LID FEATURE MARK-UP

ADDITION AND RENOVATIONS FOR:

THE QUEEN

PROJECT ADDRESS: 21-51 QUEEN STREET NORTH, MISSISSAUGA, ONTARIO

LANDSCAPE PLAN

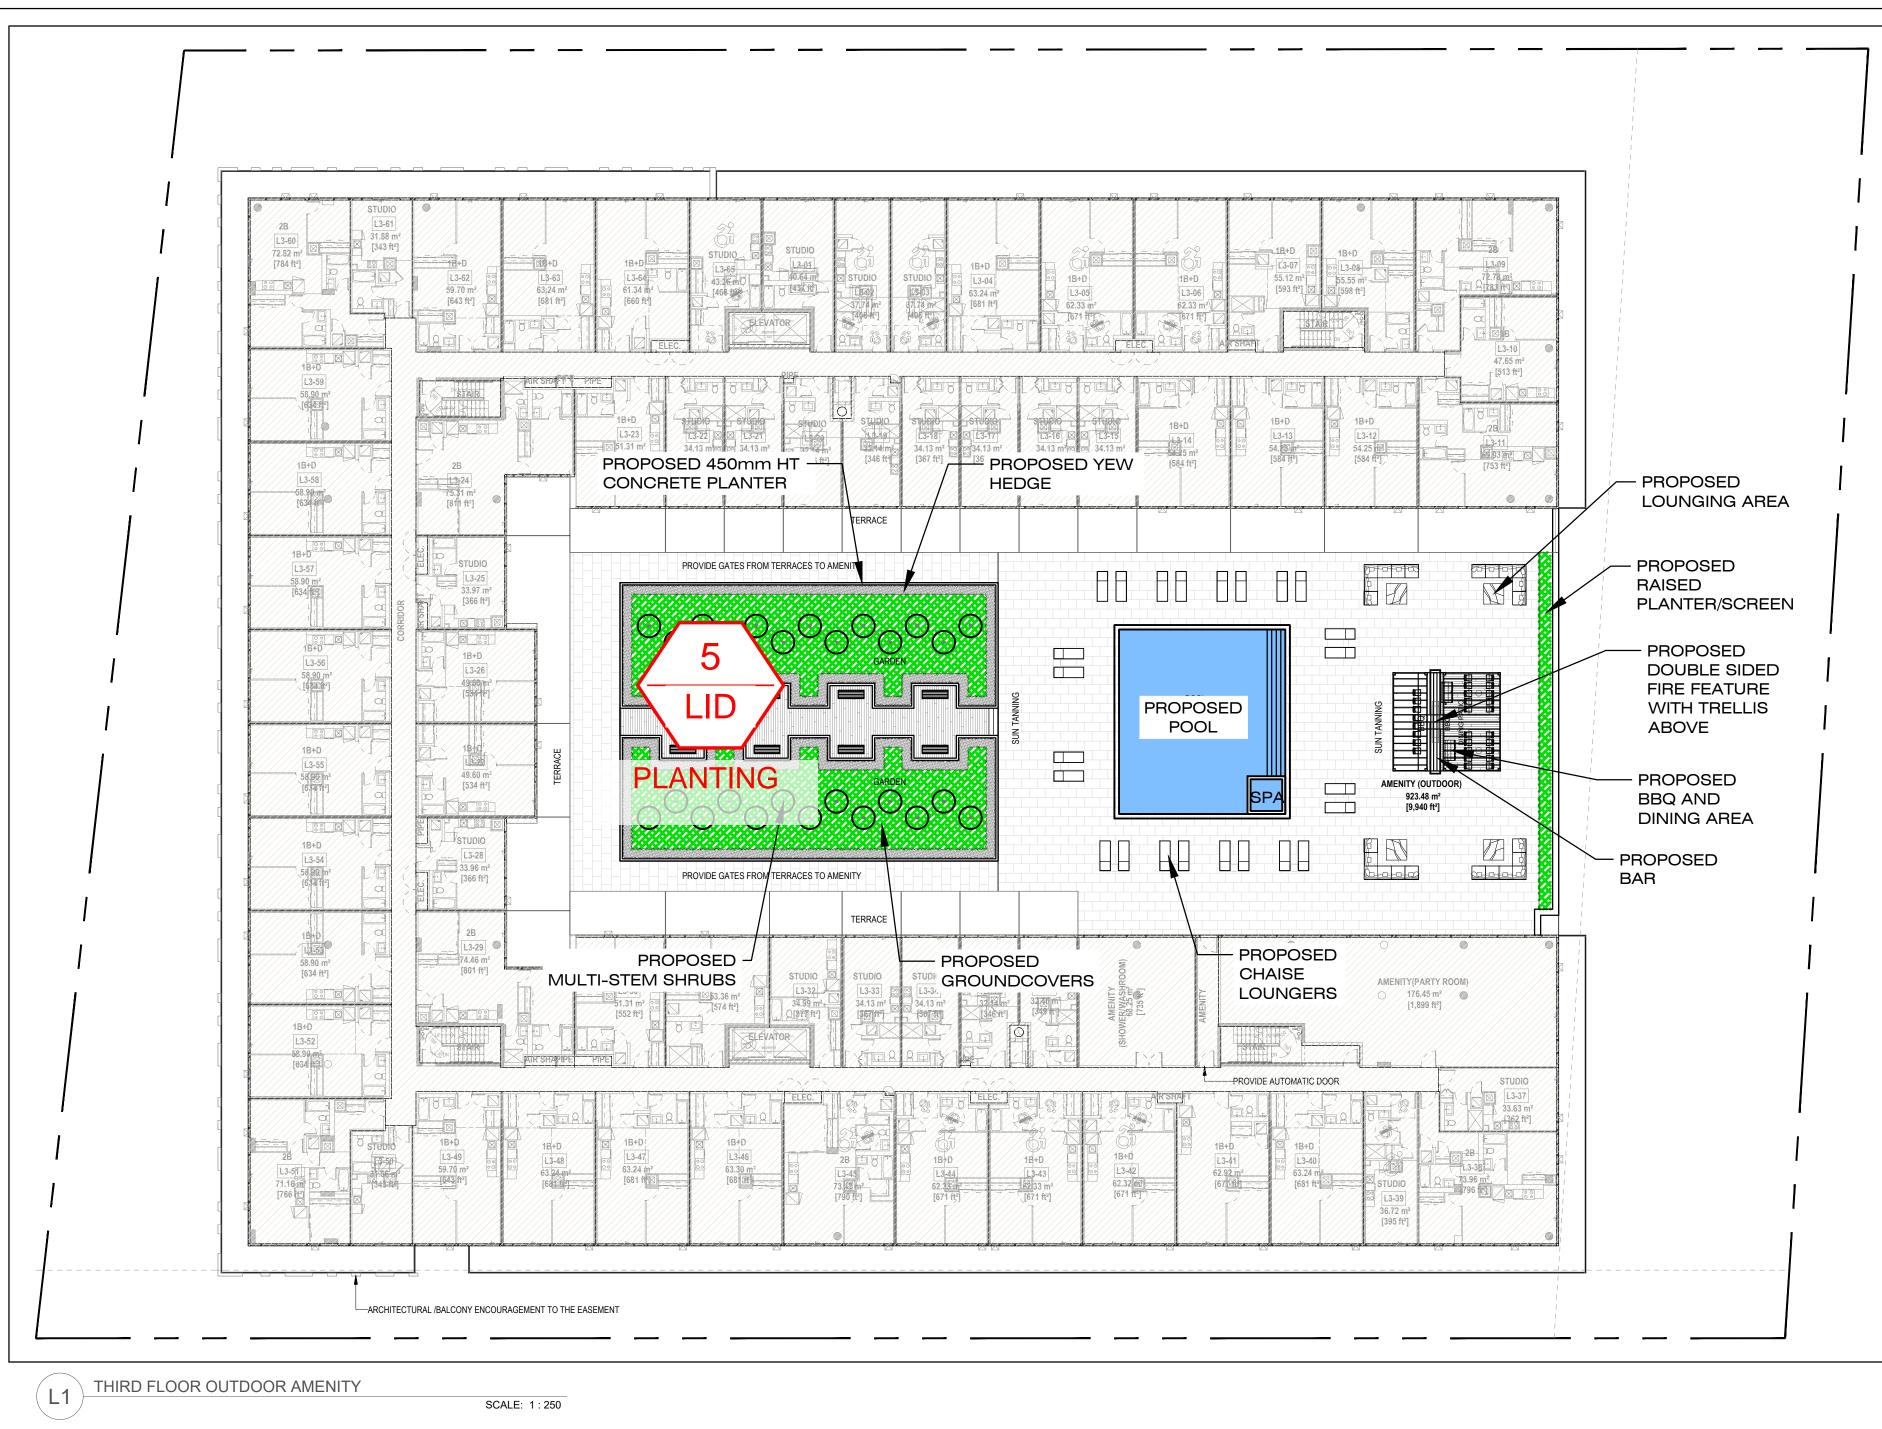
REFERENCE TO LID

BRIEF DESCRIPTION OF **GREENROOF** FEATURE

LVL.3 OUTDOOR AMENITY PLAN, GREEN ROOF AND DETAILS

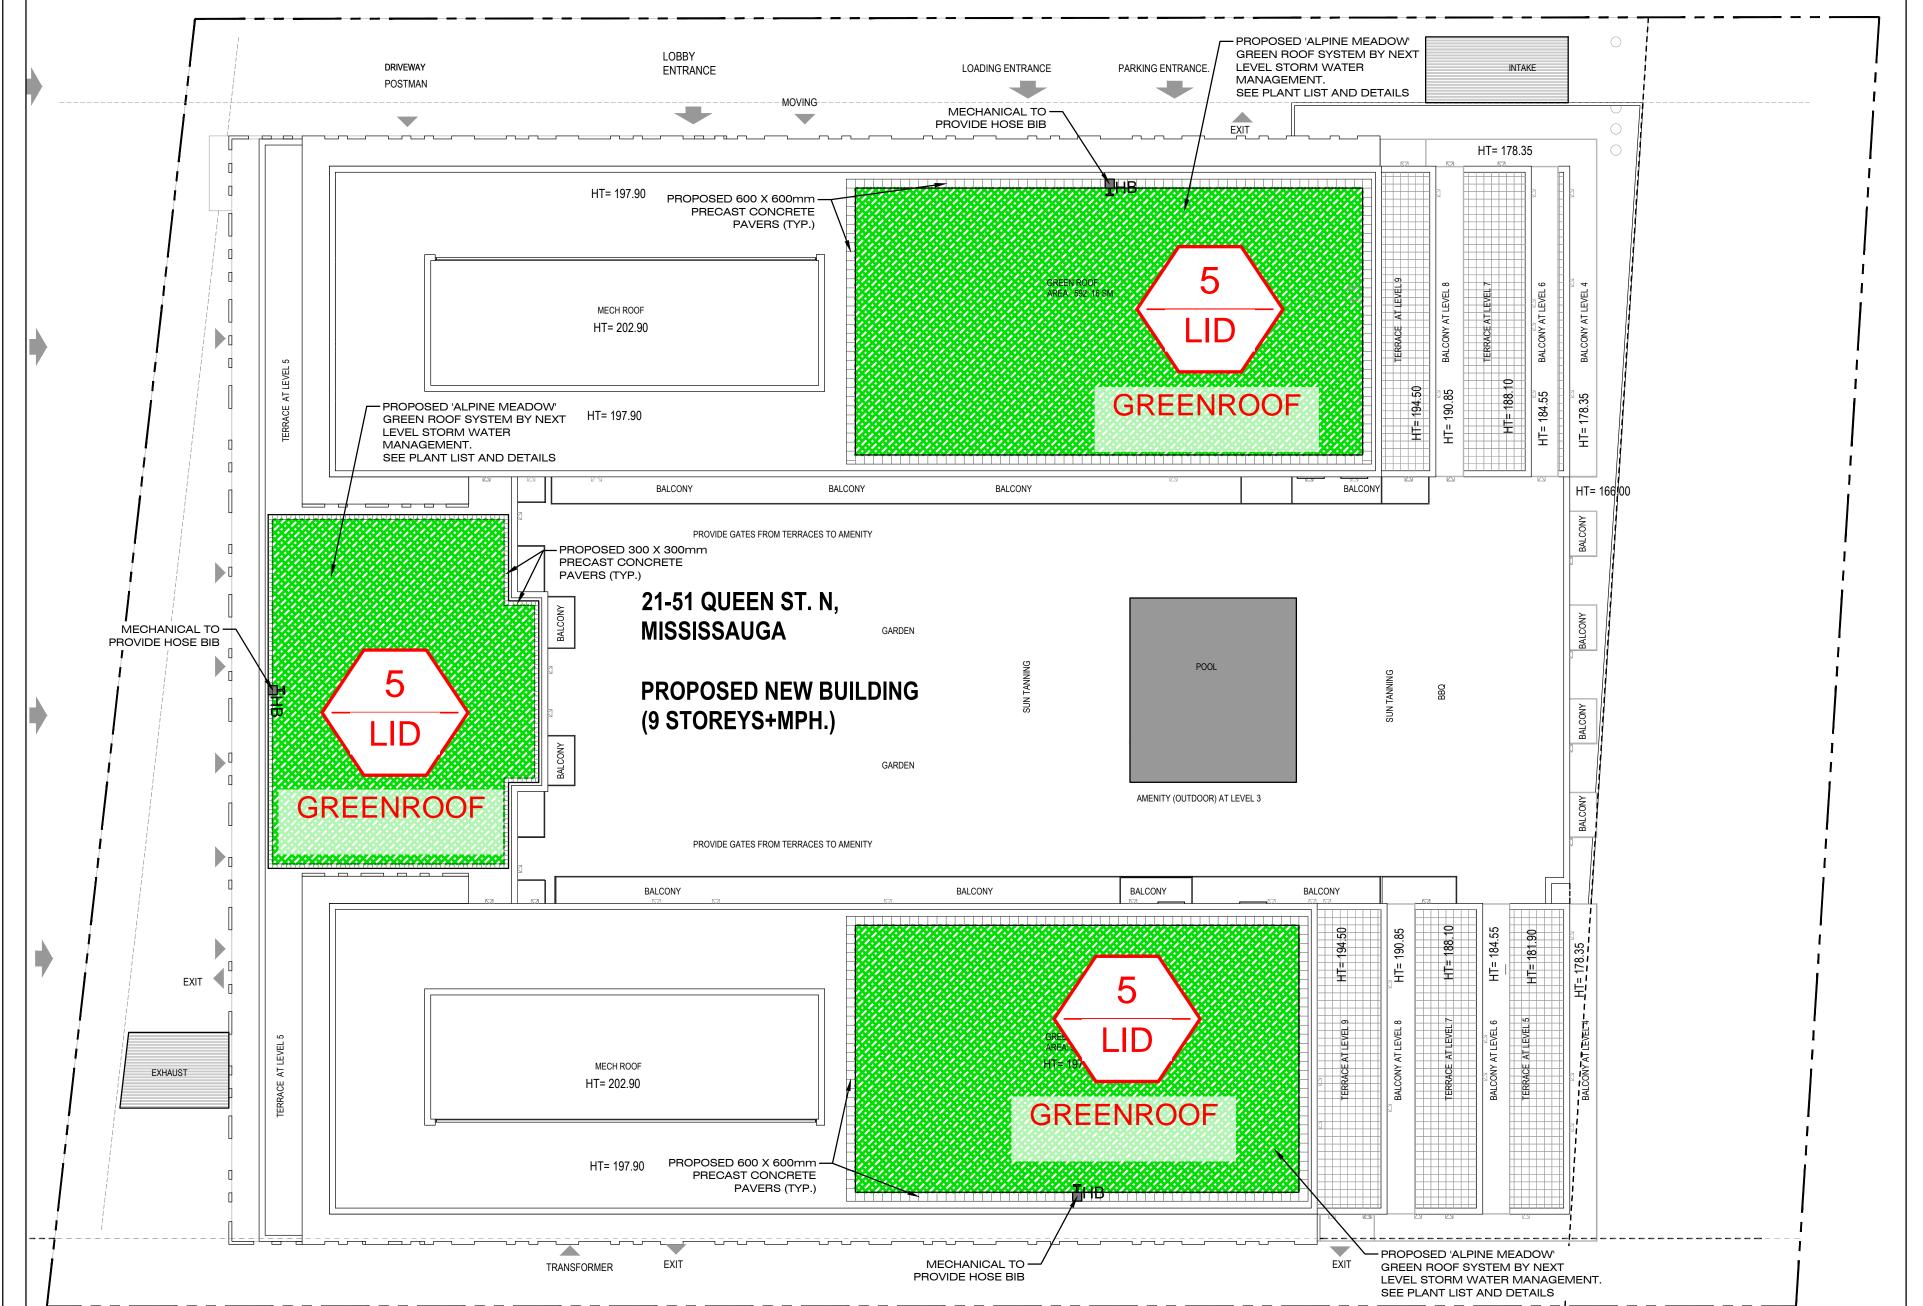
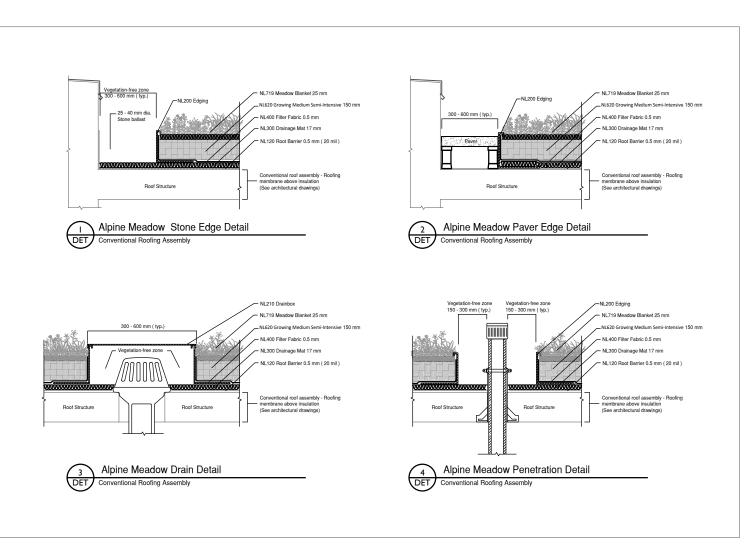
REFERENCE TO LID LIST ITEM NUMBER BRIEF DESCRIPTION OF GREENROOF-FEATURE

BUILDER TO SUPPLY EXTERNAL HOSE BIB CONNECTIONS TO GREEN ROOF FOR WATERING AND MAINTENANCE PURPOSES PROVIDE MINIMUM 2 LOCATIONS BASED ON GREEN ROOF COVERAGE. MECHANICAL TO SUPPLY FINAL HOOKUP LOCATIONS.
